***Docket Item #10  
Development Site Plan #2021-00012  
Subdivision #2022-00005  
5801 and 6001 Duke Street  
West End (Landmark) Infrastructure Plan***

<b>Purpose of Application</b>
Approval of a Development Site Plan with Subdivision and street dedication to construct sitewide infrastructure for the Landmark Mall redevelopment; zoned: CDD #29/Coordinated Development District #29

<b>Staff Recommendation: APPROVAL WITH CONDITIONS</b>
<b>Staff Reviewers:</b> Jared Alves, AICP, Urban Planner III, <a href="mailto:Jared.Alves@AlexandriaVA.gov">Jared.Alves@AlexandriaVA.gov</a> Maya Contreras, Principal Planner, <a href="mailto:Maya.Contreras@AlexandriaVA.gov">Maya.Contreras@AlexandriaVA.gov</a> Robert Kerns, AICP, Division Chief, <a href="mailto:Robert.Kerns@AlexandriaVA.gov">Robert.Kerns@AlexandriaVA.gov</a>

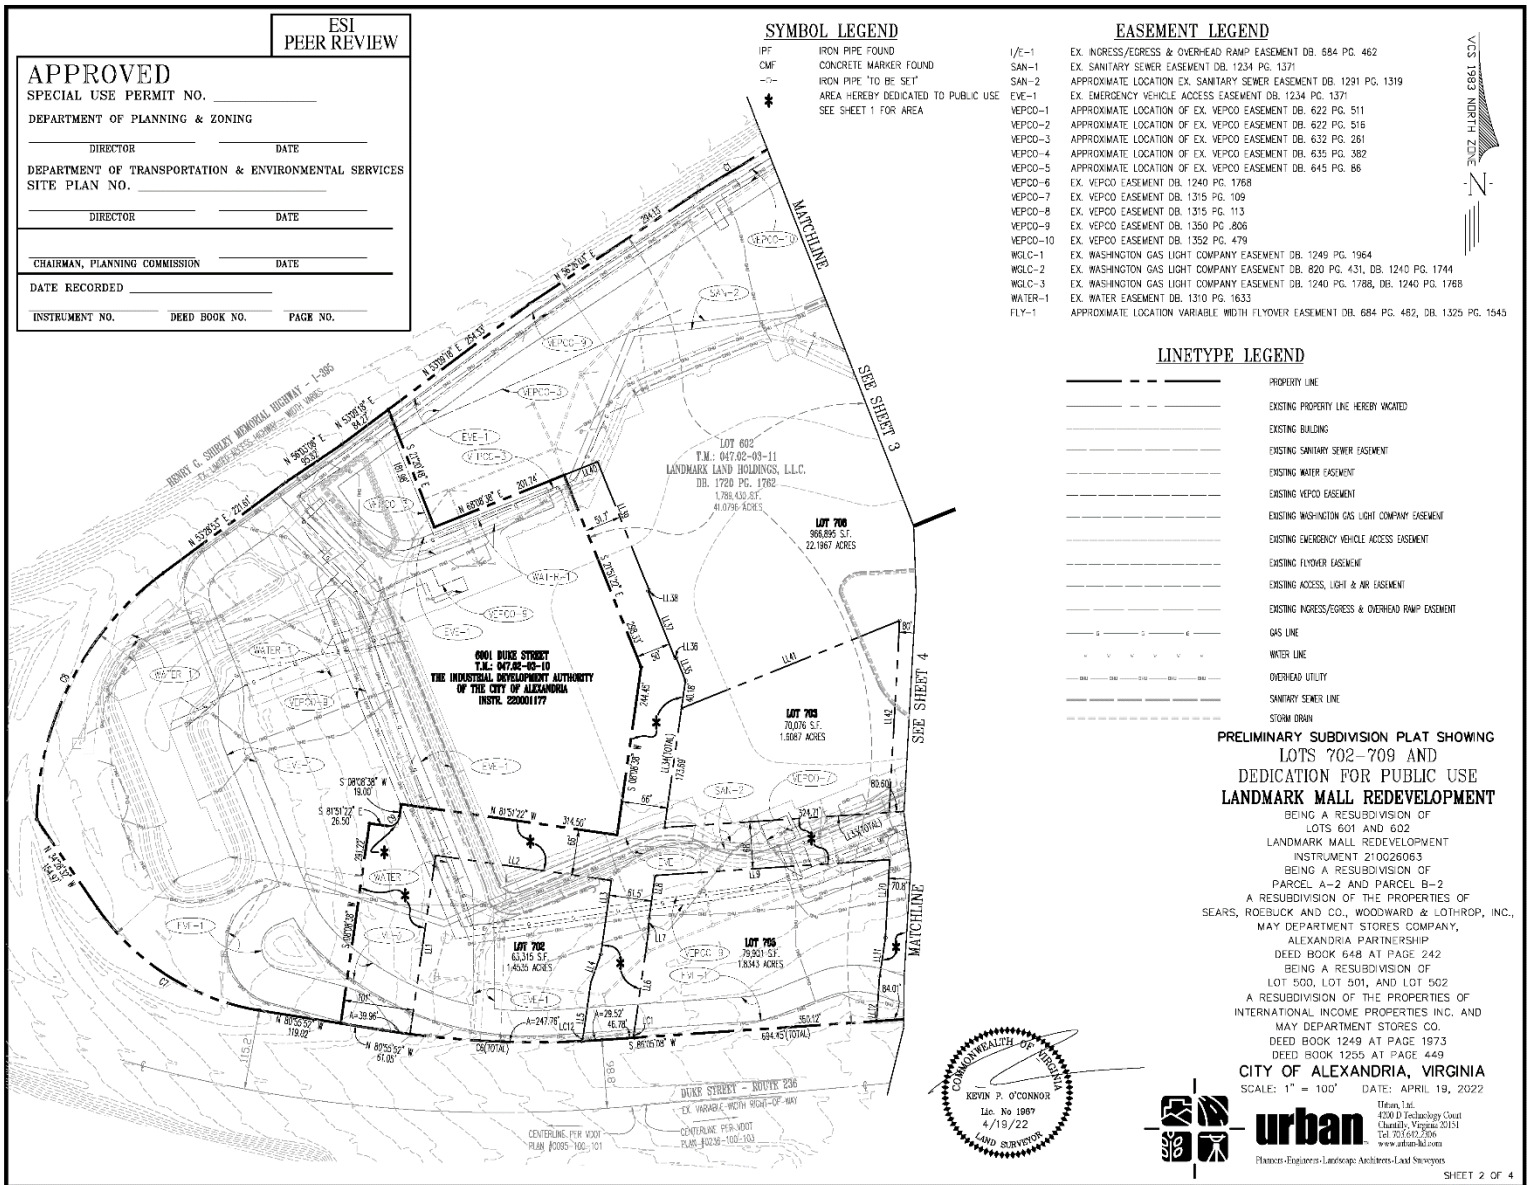
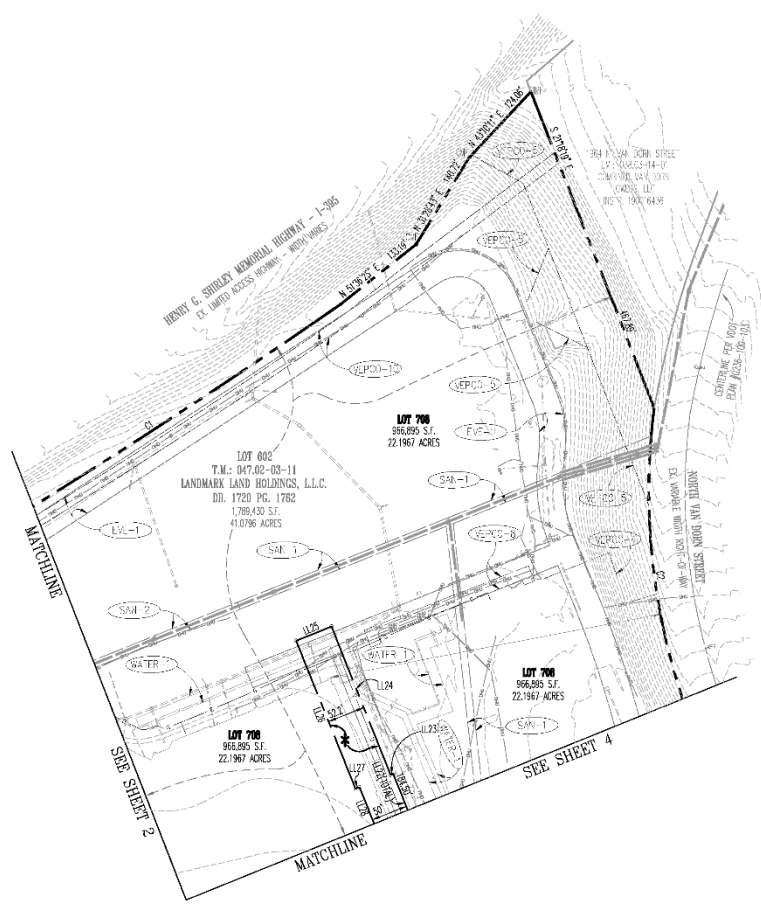
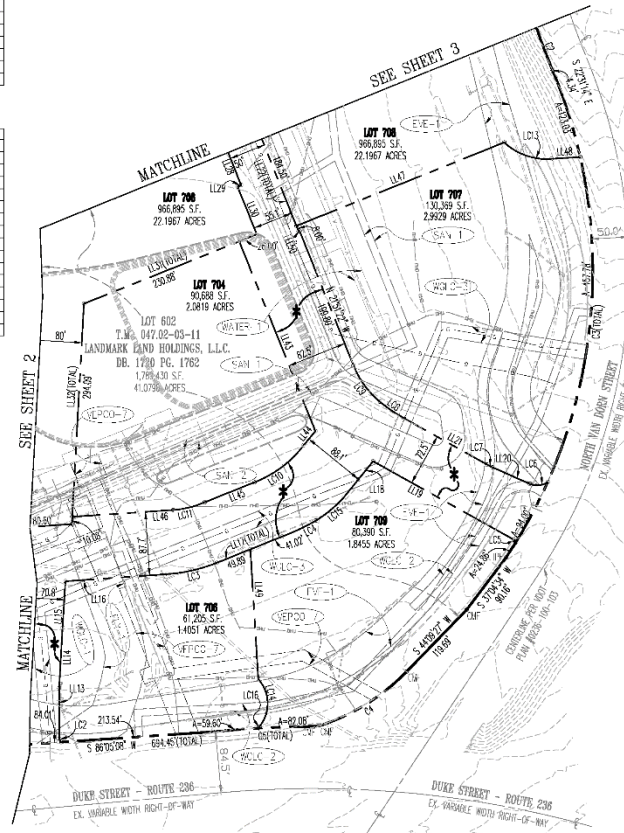
- f. Facilitate with the adjacent owner the dedication for right-of-way the additional 48 sq. ft. portion of Lot 601 as shown on the Preliminary Subdivision Plat dated April 19, 2022 and update the final site plan to include this additional dedication area. \*

- e. Combine Sheets 3 and 4 to create a 3-page plat,
  - f. Consider revising the wording in the plat title and surveyor’s certificate to remove Lot 601 from the subdivision component since this lot is only dedicating for street purposes,

**Exhibit A - Crosswalk Alignment for Intersection of Roads 1 and 6**

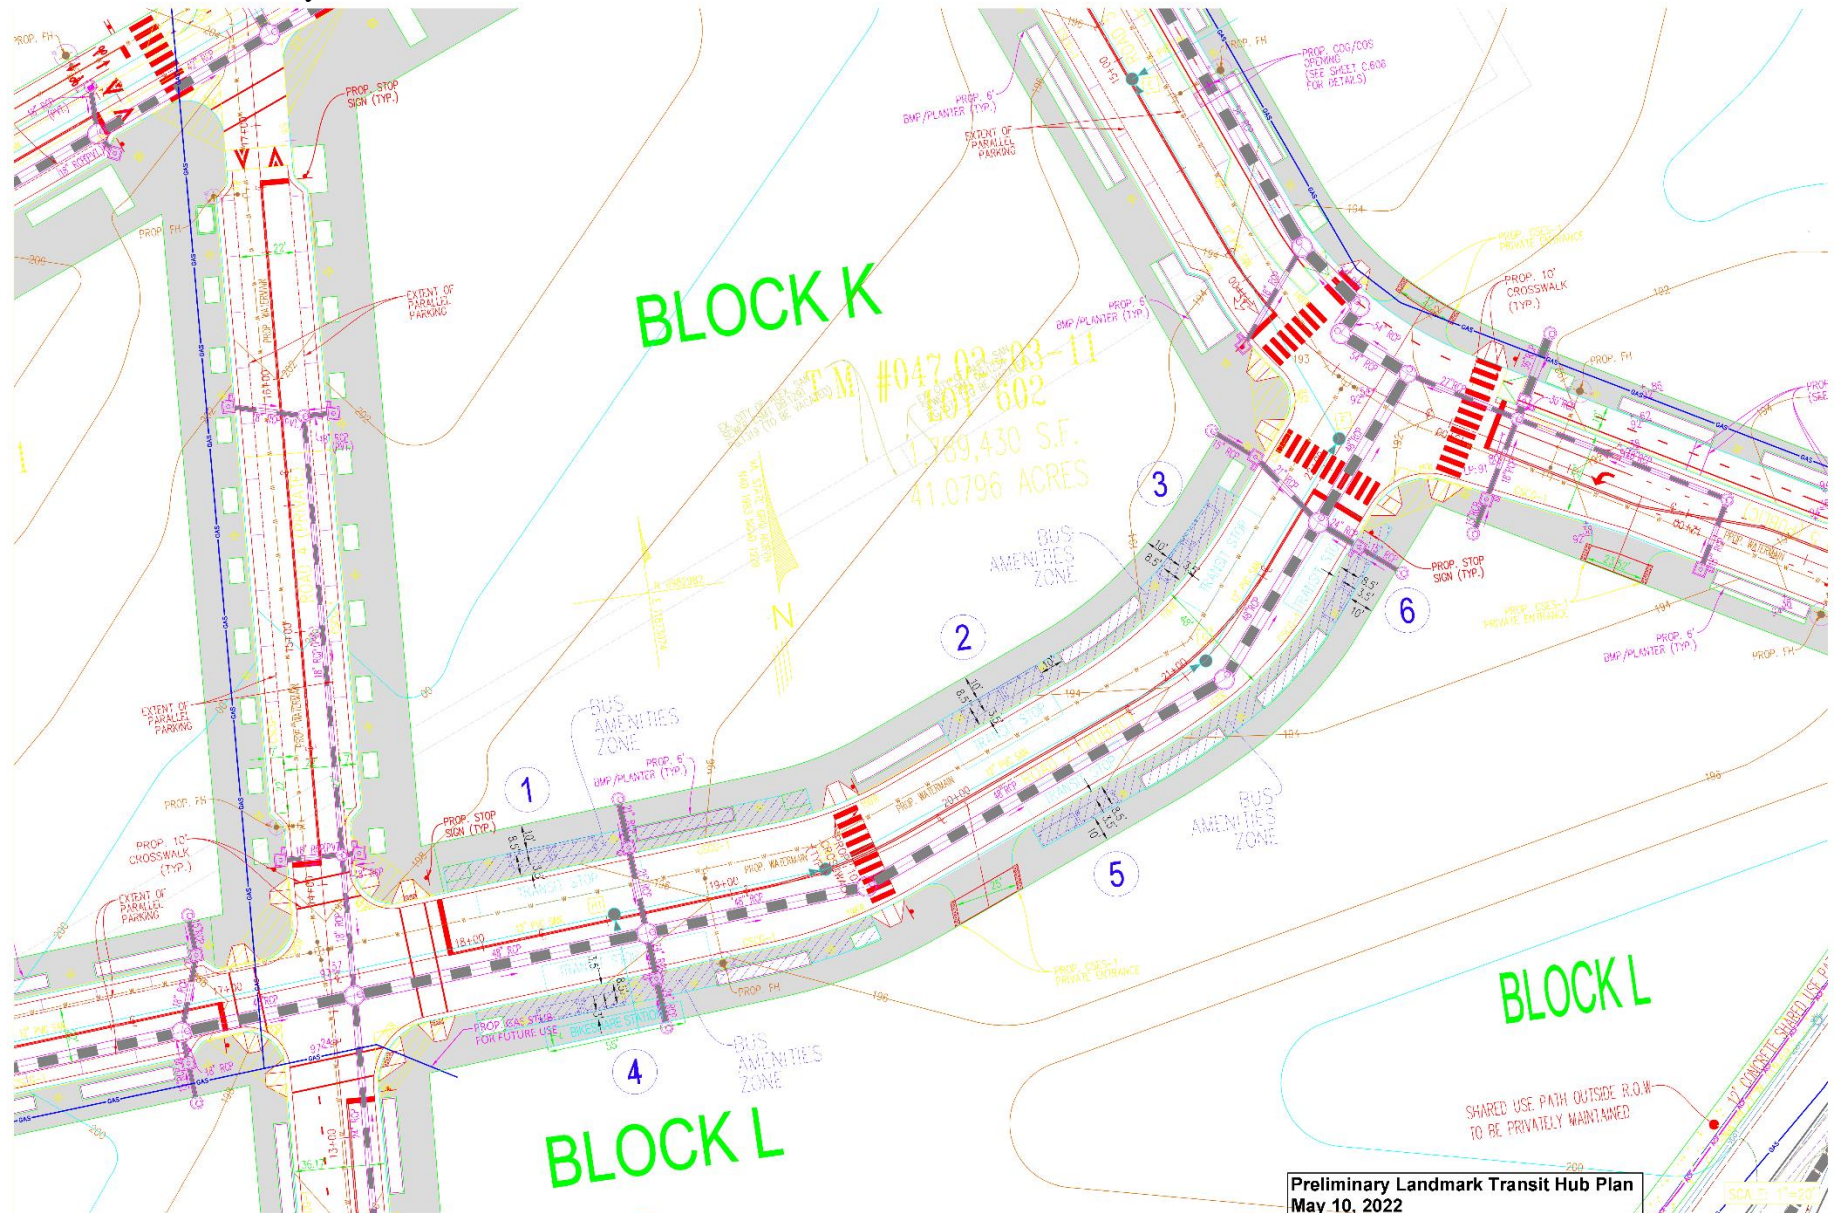
- i. The Final Site Plan shall show adjustments at these intersections: (T&ES)
  - i. To the extent practical with the roadway alignment shown in the preliminary plan, align crosswalks to connect more directly to sidewalks and pedestrian paths, accounting for the bike lane and bollard placements at the intersection of Roads 1 and 6 as generally shown in Exhibit A provided by Gorove Slade on April 22, 2022.
